SUBJECT: 4824 Edgemoor Lane
CR Public Benefit Points - Recycling Facility Plan

Re: **SITE DEVELOPMENT STORMWATER
MANAGEMENT PLAN** Request for Edgemoor
Project Phase: na
Preliminary Plan #: 12020070
SM File #: 285454
Tract Size/Zone: 0.18 ac. / CR-2
Total Concept Area: 0.26 ac.
Lots/Block: P16/13
Parcel(s): na
Watershed: Little Falls Branch

**Department of Permitting Services
Fire Department Access and Water Supply Comments**

820210040 4824 Edgemoor Lane

SITE DEVELOPMENT
STORMWATER
MANAGEMENT PLAN

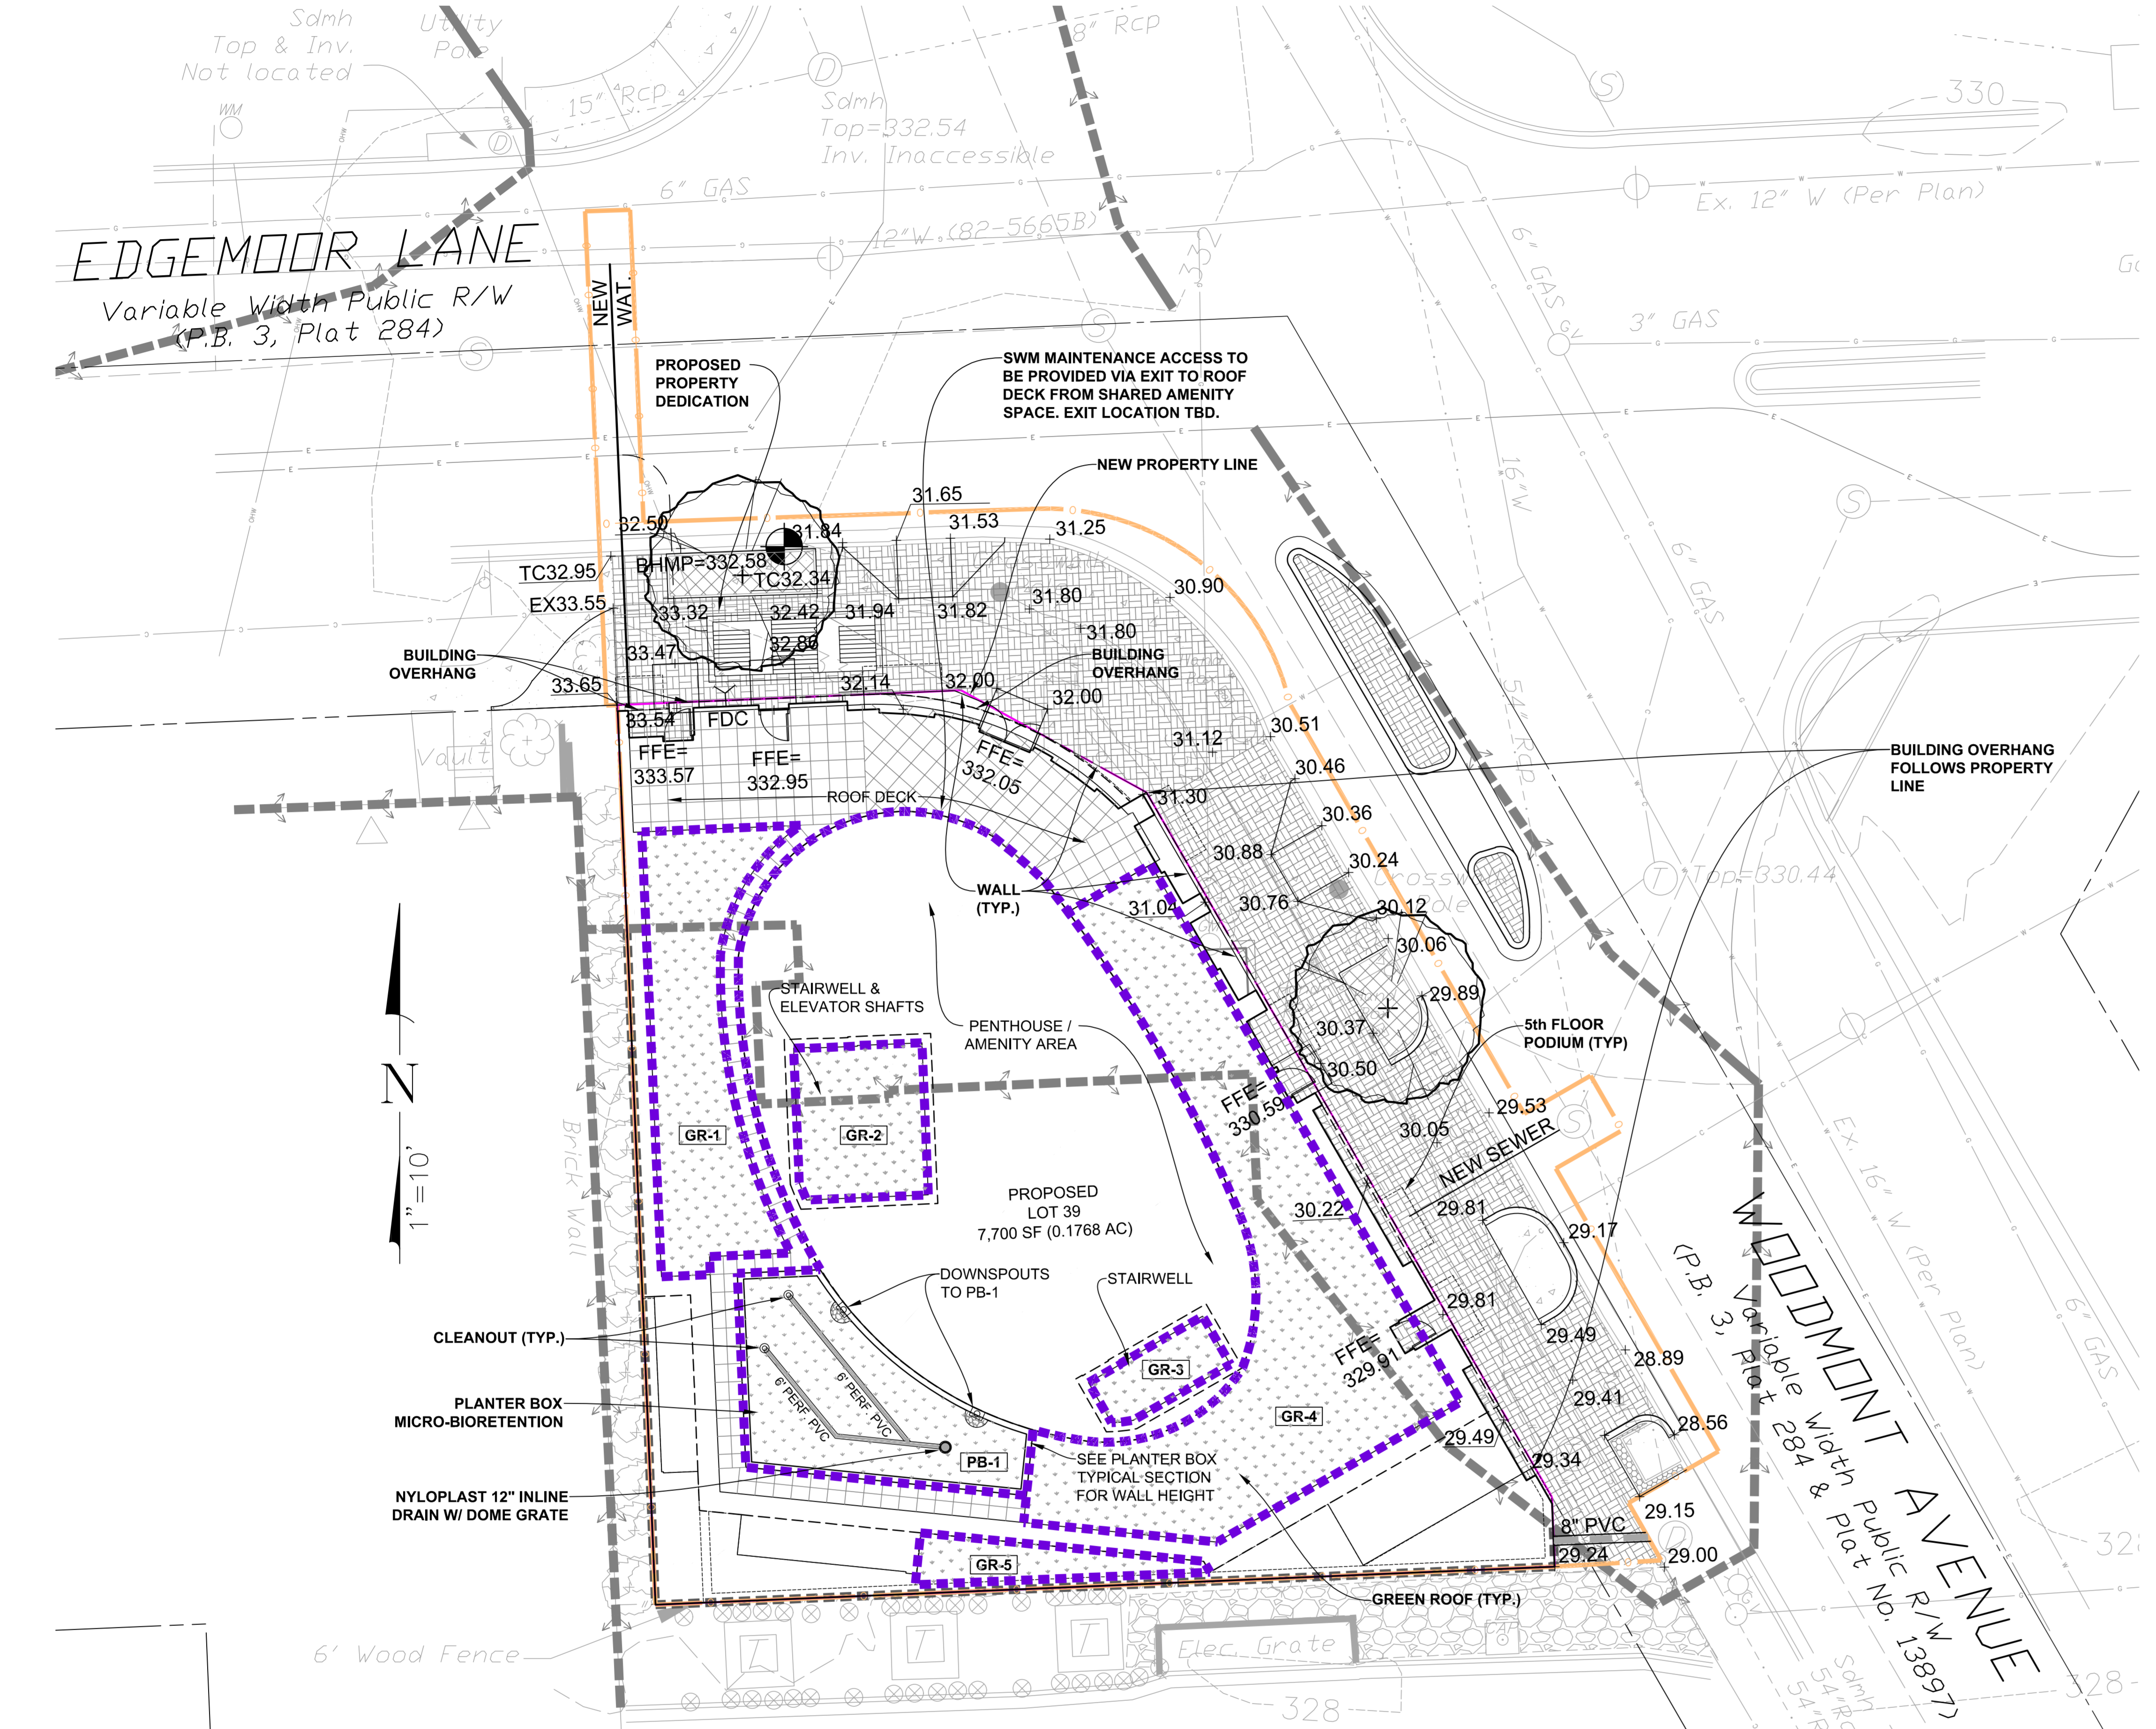
Layout for the Site
Development
Stormwater
Management Plan is
acceptable. 1/6/2021
David Kuykendall

PERFORMANCE BASED DESIGN STATEMENT

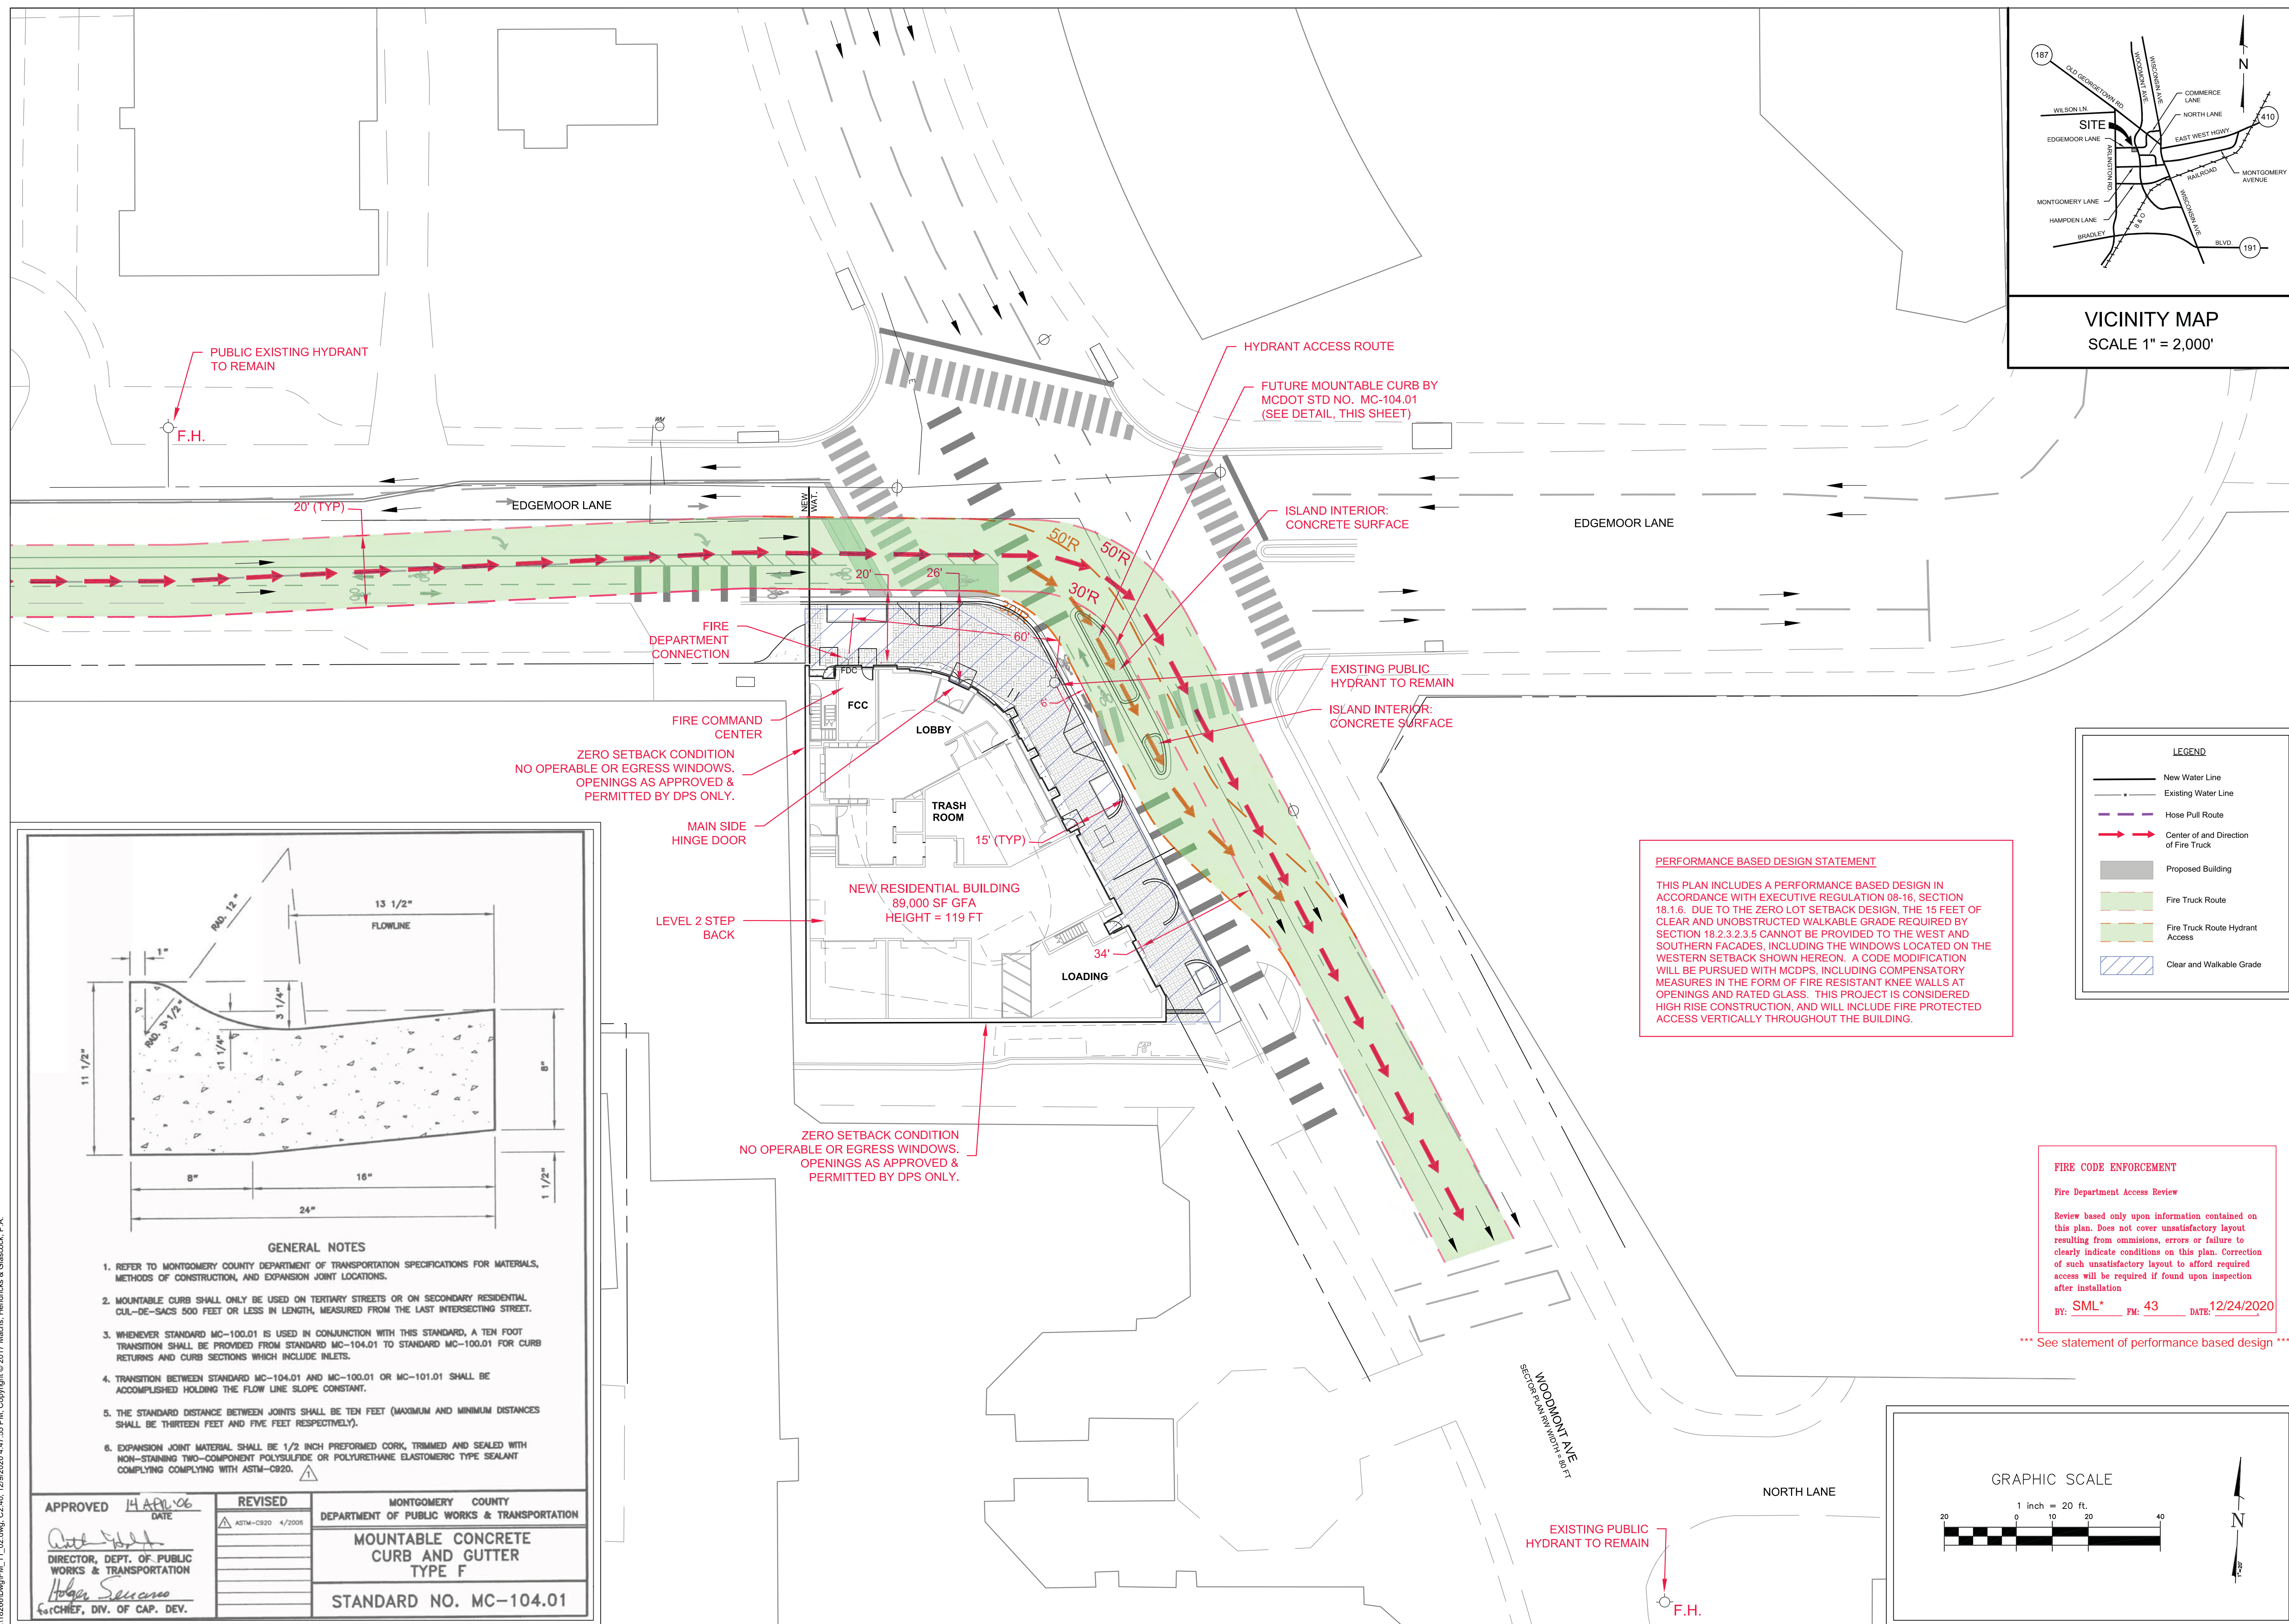
THIS PLAN INCLUDES A PERFORMANCE BASED DESIGN IN ACCORDANCE WITH EXECUTIVE REGULATION 08-16, SECTION 18.1.6. DUE TO THE ZERO LOT SETBACK DESIGN, THE 15 FEET OF CLEAR AND UNOBSTRUCTED WALKABLE GRADE REQUIRED BY SECTION 18.2.3.2.3.5 CANNOT BE PROVIDED TO THE WEST AND SOUTHERN FACADES, INCLUDING THE WINDOWS LOCATED ON THE WESTERN SETBACK SHOWN HEREON. A CODE MODIFICATION WILL BE PURSUED WITH MCDPS, INCLUDING COMPENSATORY MEASURES IN THE FORM OF FIRE RESISTANT KNEE WALLS AT OPENINGS AND RATED GLASS. THIS PROJECT IS CONSIDERED HIGH RISE CONSTRUCTION, AND WILL INCLUDE FIRE PROTECTED ACCESS VERTICALLY THROUGHOUT THE BUILDING.

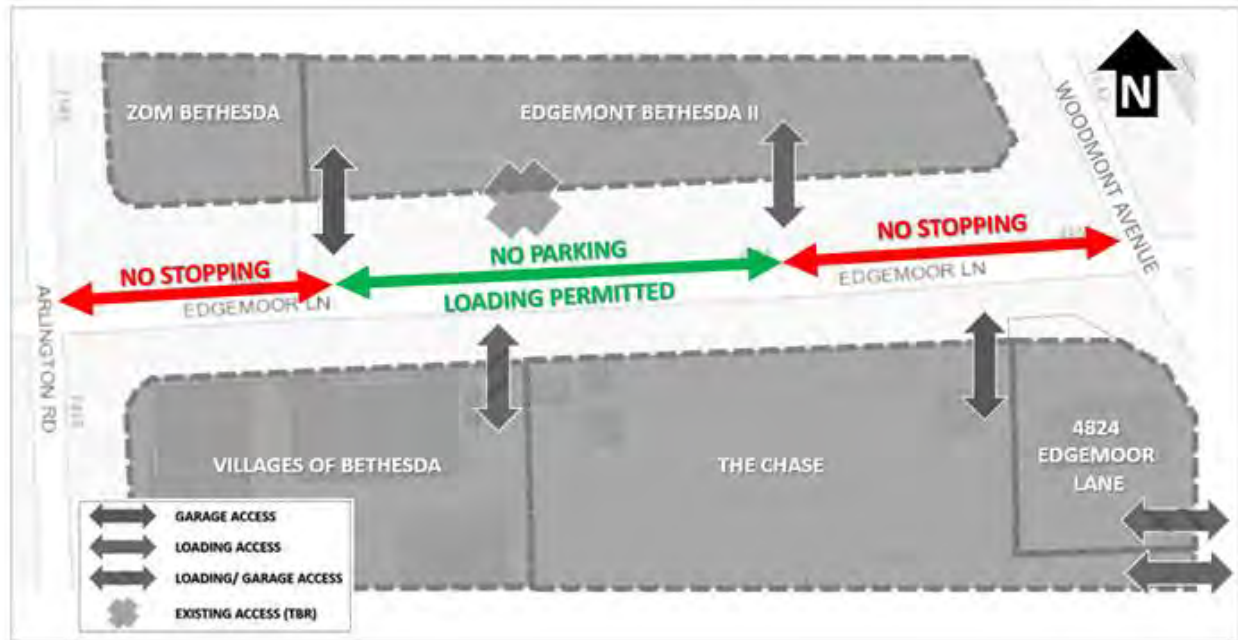
If I understand you correctly, the area MCDOT would accept as a loading space is located in the area highlighted on the map below. Can you please confirm this is your intent?

Correct, the limits you have shown in the map are what we are recommending in regards to parking restriction signage.
